Applicant: Ken Kraft; Frauenshuh  
Consultant: Becky Guenther; ISG  
Project: France Place Sanitary Sewer Improvements  
Location: 3601 Minnesota Drive, Bloomington, MN  
Applicable Rule(s): 4, 5, 11 and 12  
Reviewer(s): Josh Phillips and Louise Heffernan; Barr Engineering Co.

The applicant proposes the replacement of a portion of sanitary sewer at France Place, located at 3601 Minnesota Drive in Bloomington. The 8-acre parcel is occupied by a commercial building and surface parking lots. The project will include construction of permeable pavers to provide rate control, volume retention, and water quality management within the paver foundation material for the 5,105 square-feet of disturbed area on the site including the 4,455 square-feet of reconstructed impervious surfaces.

SHEET  
**C3-10**

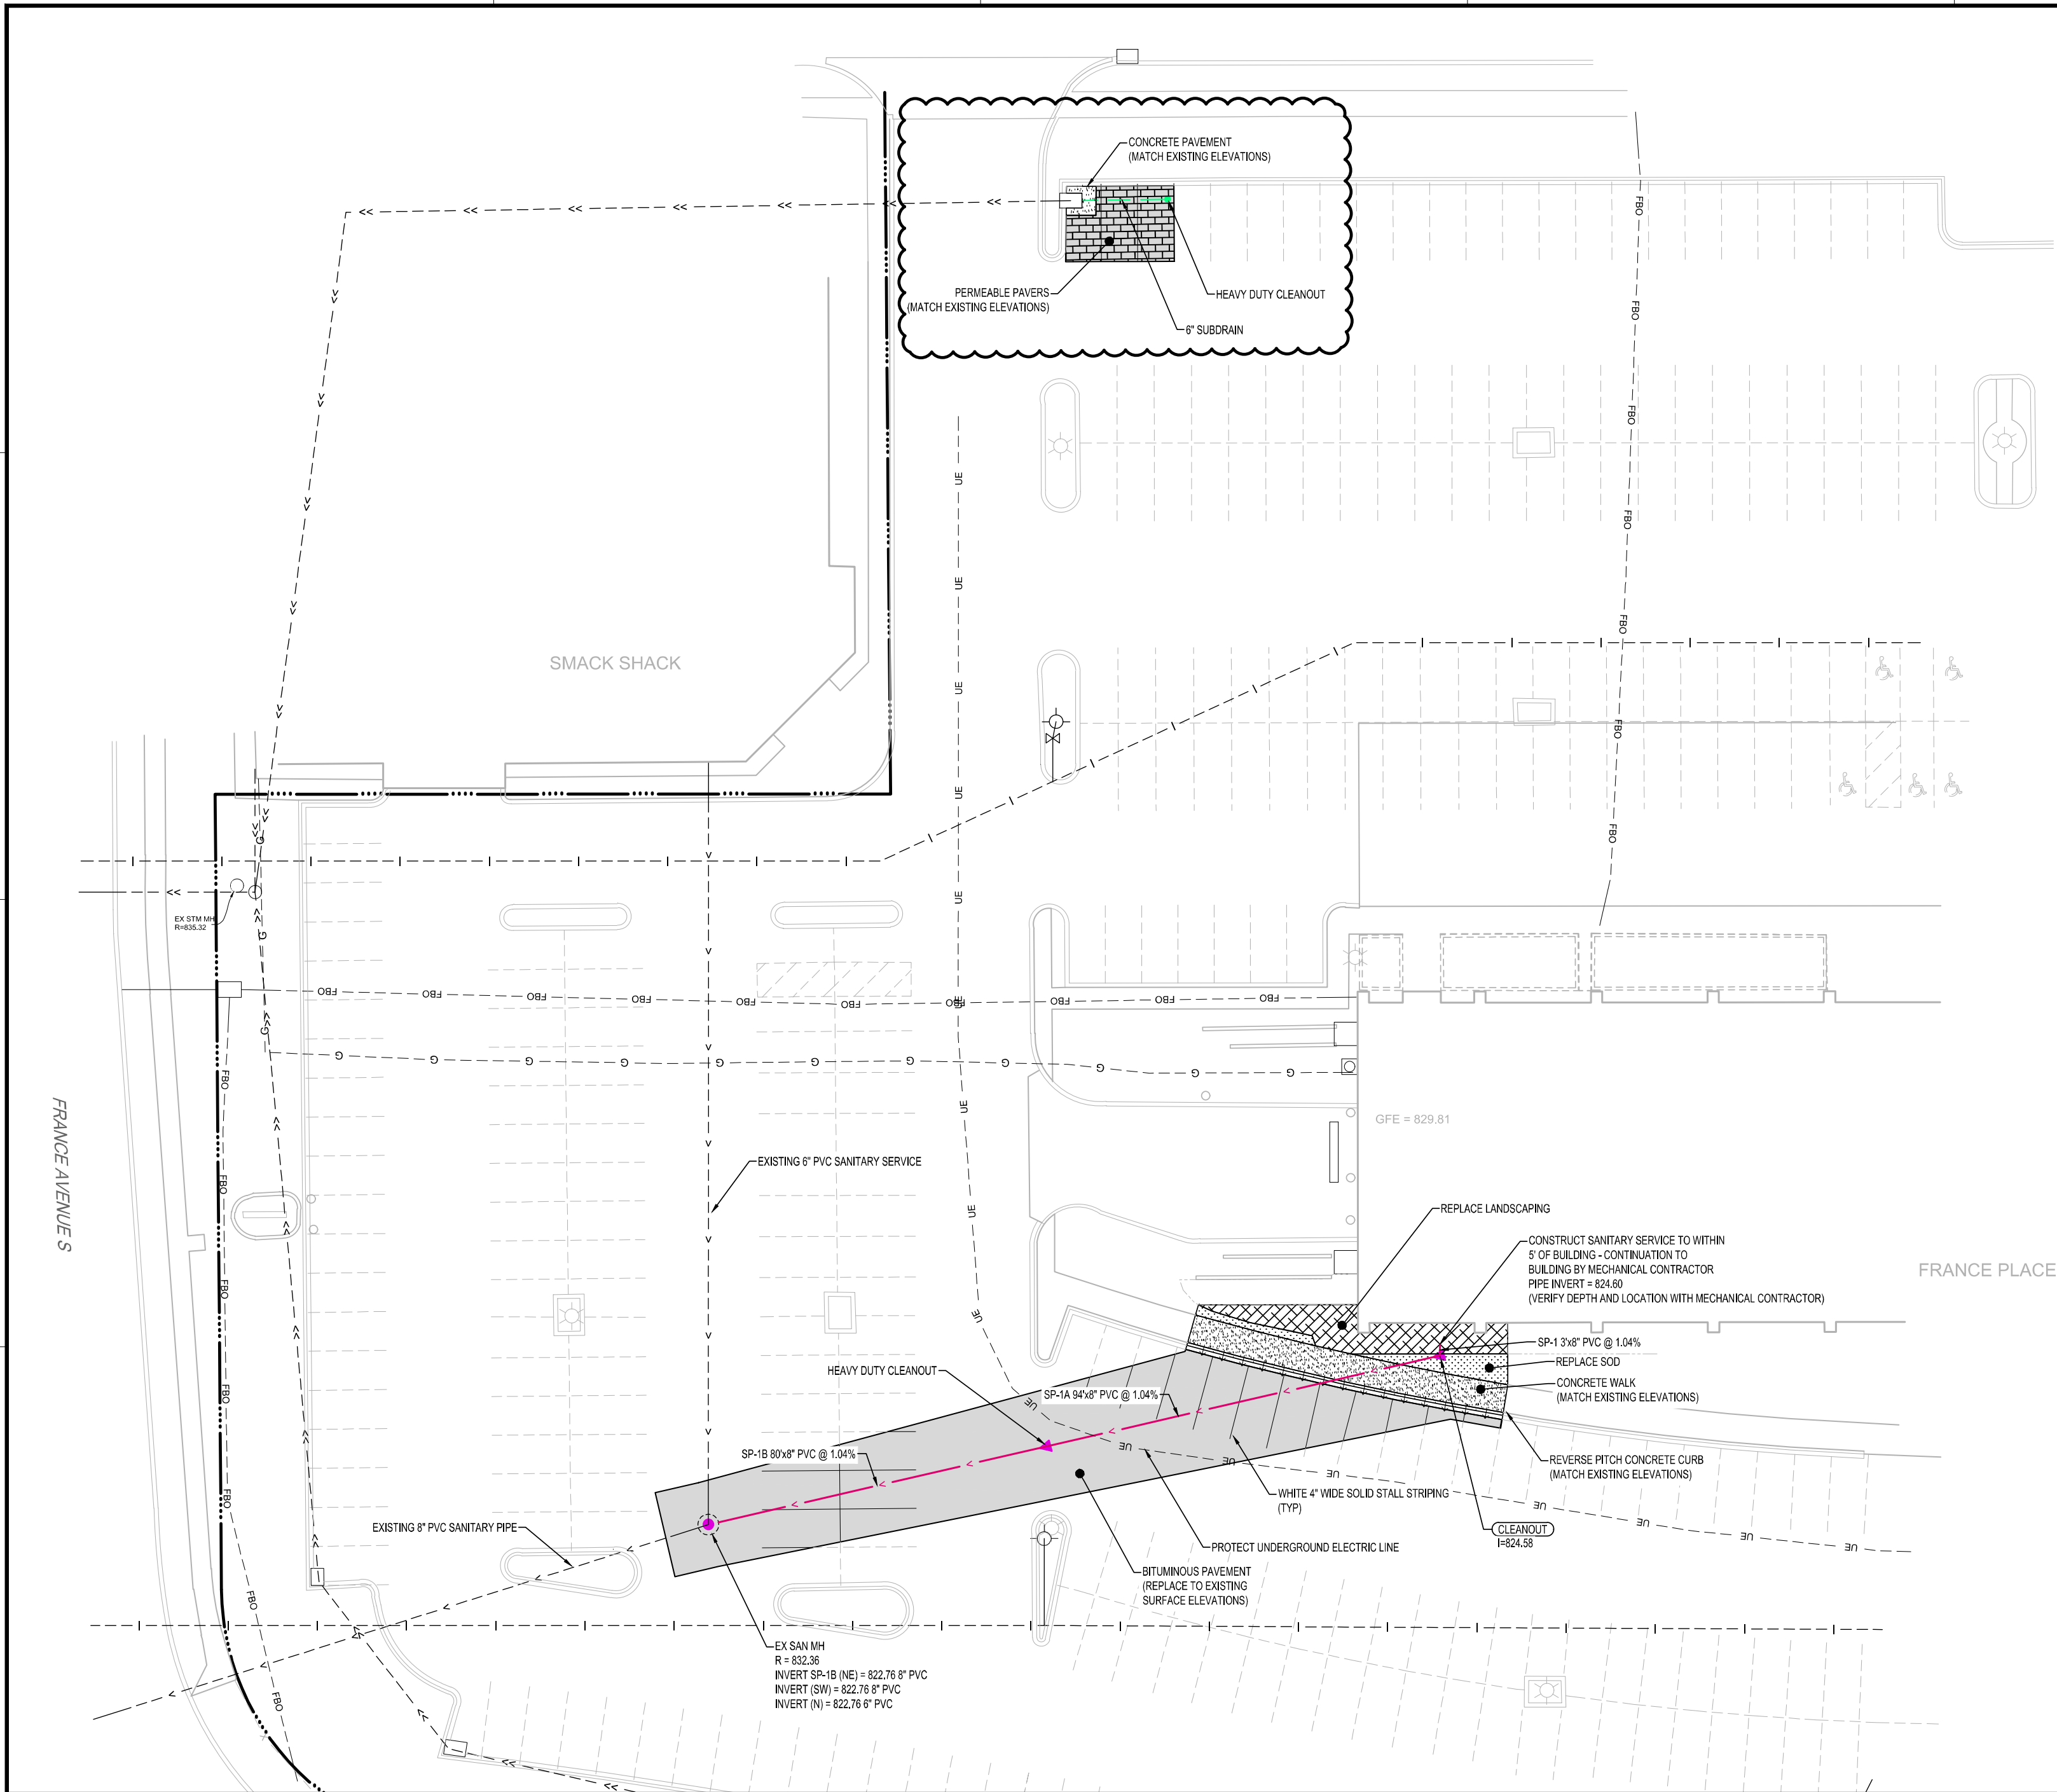
A retention volume of 409 cubic feet is required from the proposed 4,455 square feet of regulated impervious surface. The Braun Intertec geotechnical soil boring logs identify the underlying soil within the area of the proposed stormwater management facility (ST-4) as poorly graded sand (SP). An infiltration rate of 0.8 inches per hour has been used for design, using infiltration rates for poorly graded sand identified in the Minnesota Storm Water Manual.

The table below summarizes the volume retention required and volume retention achieved. The proposed project is in conformance with subsection 4.3.1a. A retention volume of 420 cubic feet is proposed to be provided (409 cubic feet required) with an infiltration area of 393 square feet (341 square feet required).

Rule 4.5.4d (i) requires that if infiltration of runoff is proposed, data must be submitted showing no evidence of groundwater or redoximorphic soil conditions within 3 feet of the bottom of the facility, practice or system and soil conditions within 5 feet of the bottom of any stormwater treatment facility, practice or system. ST-4 completed within the area of the proposed facility did not encounter groundwater in the boring. The boring was completed to elevation 821.5 feet. The bottom of the proposed facility is 826.8 feet, providing 5.3 feet of separation between the bottom of the proposed facility and the elevation where groundwater was not encountered.

Per Rule 4.3.5, a receipt showing recordation of a maintenance declaration for the operation and maintenance of the stormwater management facility is required. A draft of the declaration must be approved by the district prior to recordation.

Per Rule 4.5.6, an as-built drawing of the stormwater management facility conforming to the design specifications, including a stage volume relationship in tabular form for the permeable pavers, as approved by the district, must be provided.
